ADDENDUM NO. 1

SUNSET BOOSTER PUMP STATION REPLACEMENT

ANTIOCH, CALIFORNIA

ISSUED
July 28, 2015

**PUMP STATION
LAYOUT PLAN**

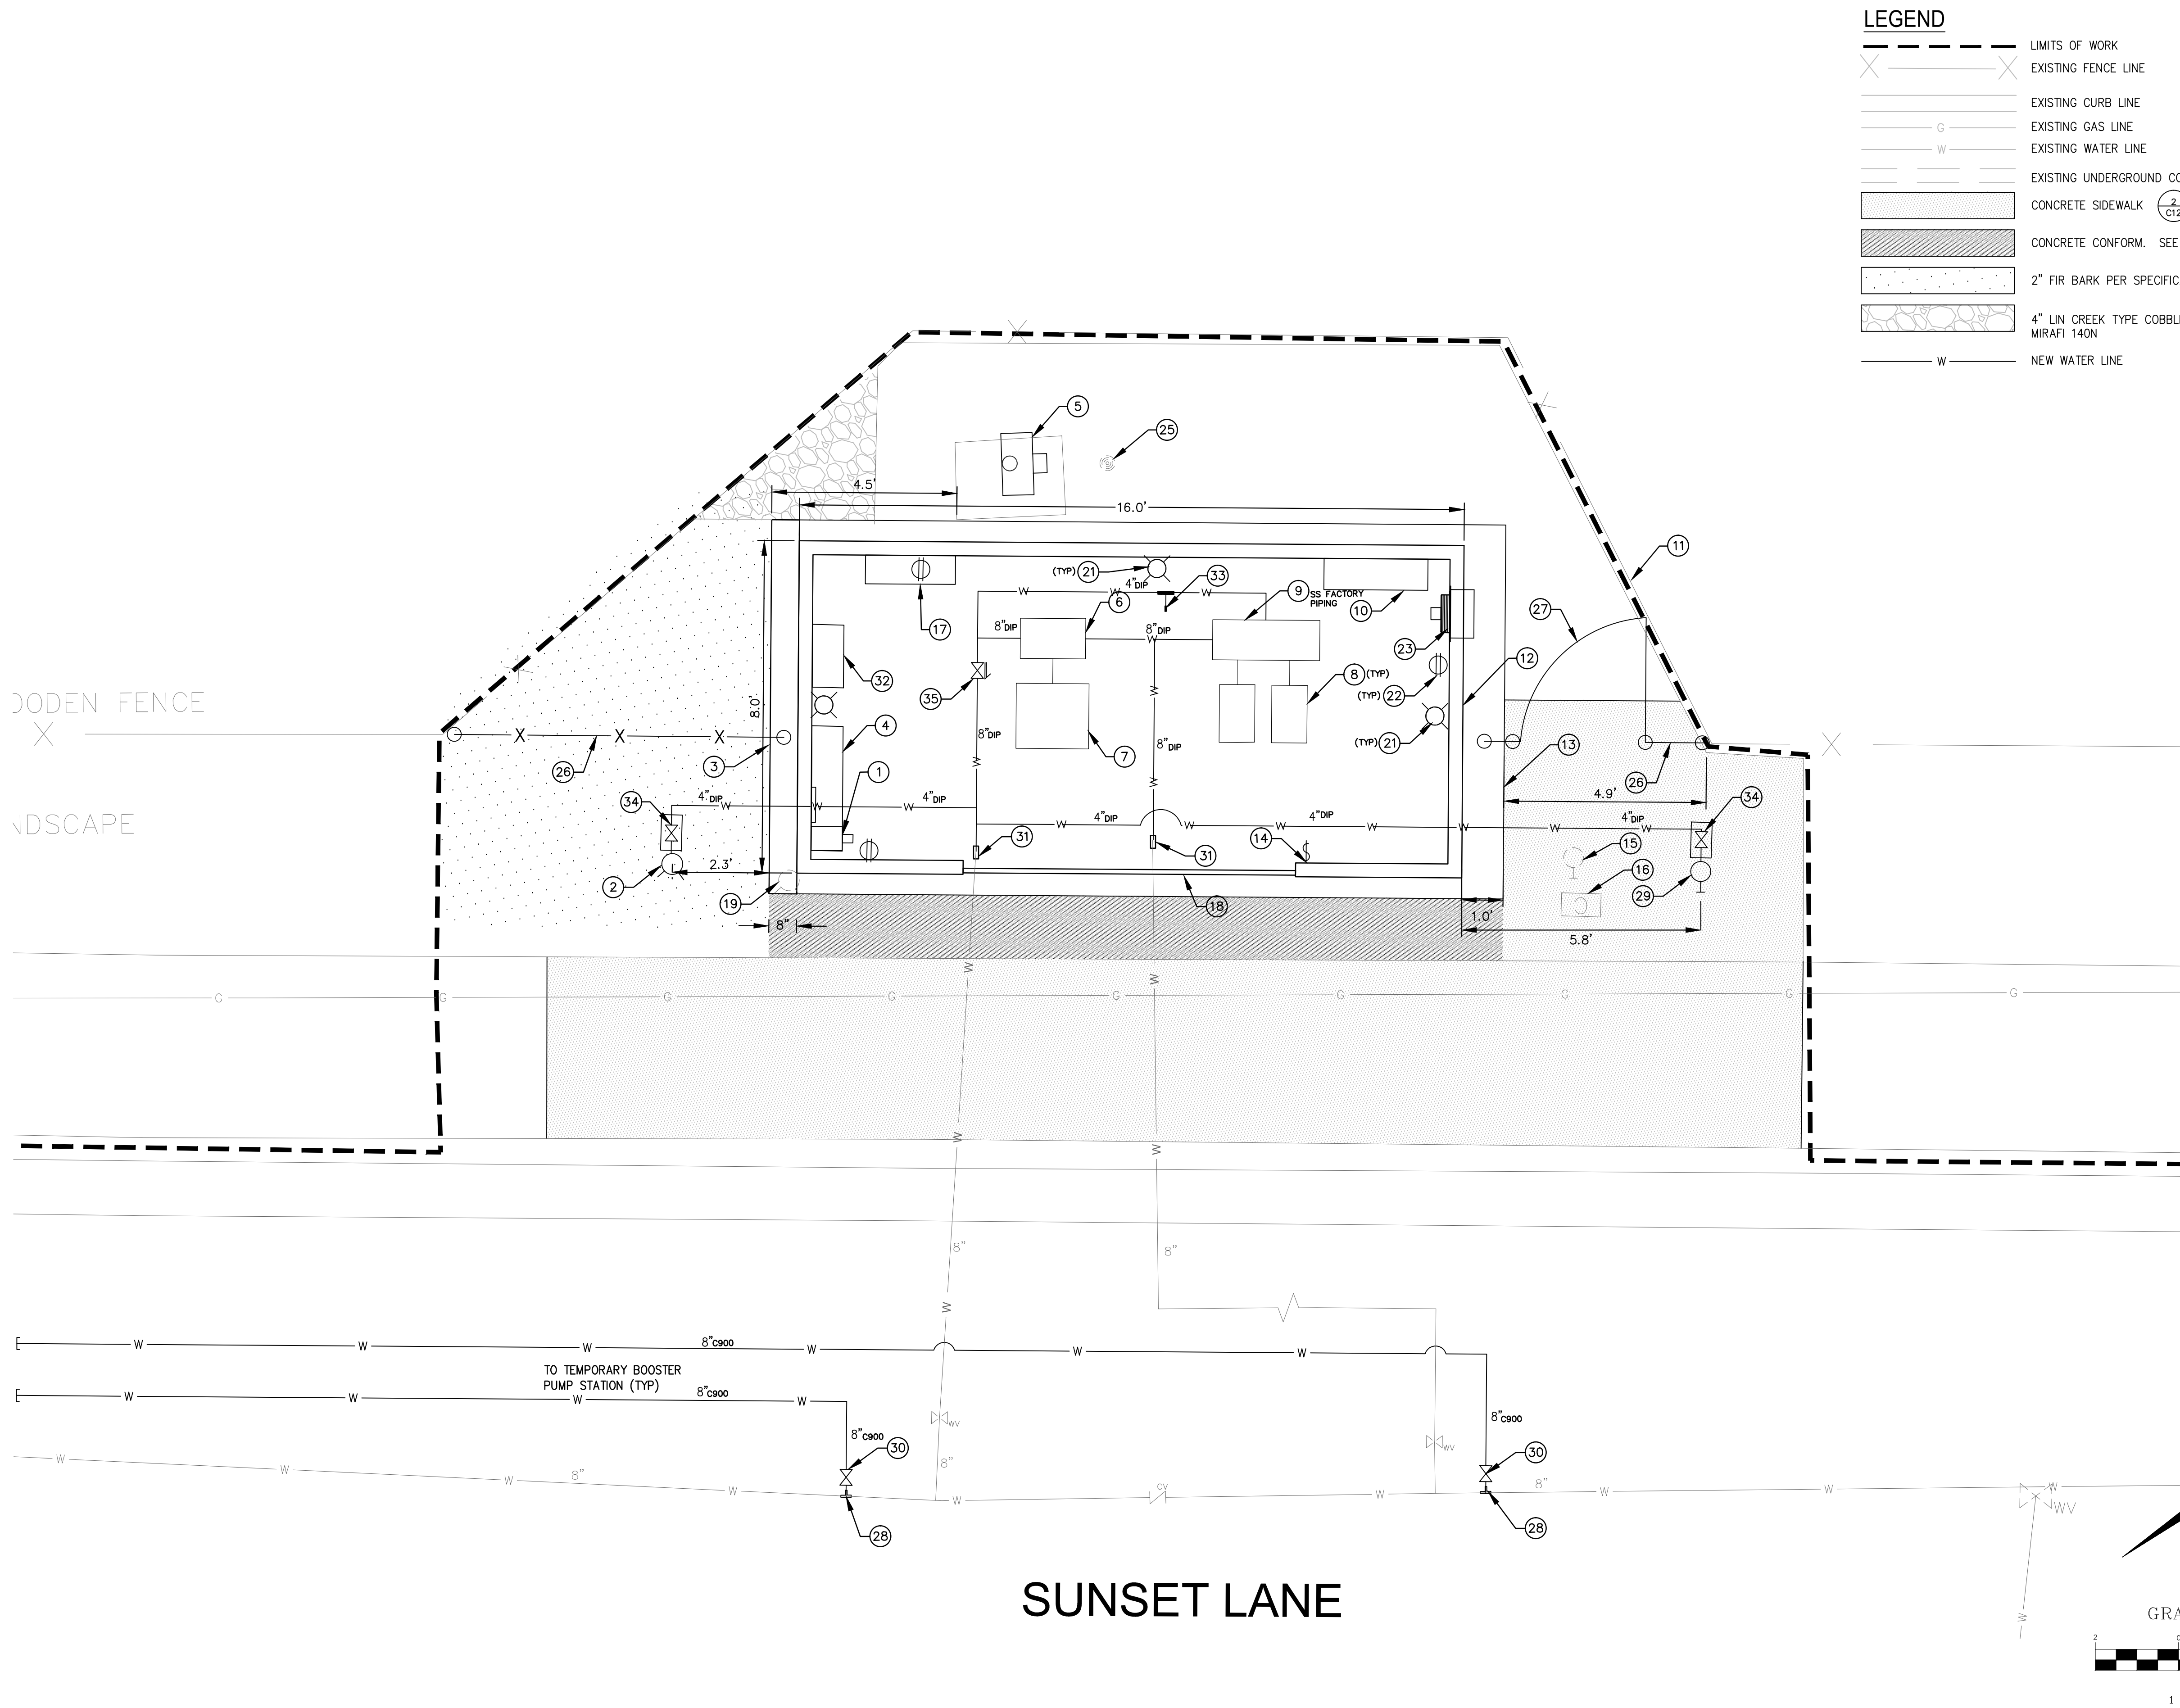
- 15) The attached revised Sheet 7A shall be use in lieu of Sheet 7 of the Project Plans.
